## **Attachment 1- Answers and Clarification Document- Addendum 3**

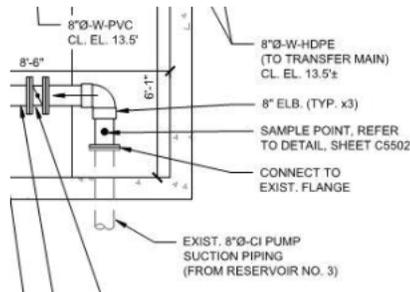
The common suction pipe that will feed all pumps is currently shown as 8" on the drawings not 6".

Based on this information it appears that the suction line may need a reduction from 8" to 6" before reaching the existing distribution pump that is to be reused. The triplex pump is on the end of the shared suction line, and thus a reduction to 6" will have no impact on the upstream pumps or pipe configuration.

**BLDC Answer: The Contractor to Accommodate for this Reduction from 8" to 6" in the Lump sum cost.**

#### **Calcium hypochlorination Systems/ RO Treated water sites**

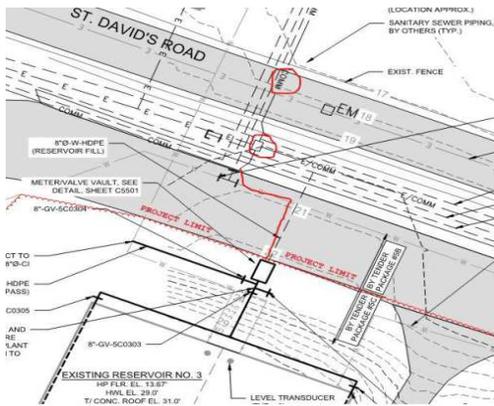
13. Can we get the cutsheets on the calcium hypochlorite disinfection system?

**BLDC Answer:** We do not have cut sheets yet, please see below a screen shot of the material to be provided along with the Manufacturer name.

#### **Calcium hypochlorination System/ Reclaim WWTP effluent**

**One (1)** MC4-50 Constant Chlor® (NFS 60) Dry Cal-Hypo Feeder pre-wired and piped, as described above.

**One (1)** ChlorTrak chemical consumption system installed on the MC4-50 feeder.

**One (1)** MC4-50 feeder Hopper Reduction Insert (for use with < 6 PPD briquette applications. (Supplied loose).

**One (1)** Peristaltic type metering pump capable of delivering 15.0 GPH against a maximum discharge pressure of 100 psig. The pump is capable of manual or automatic control..
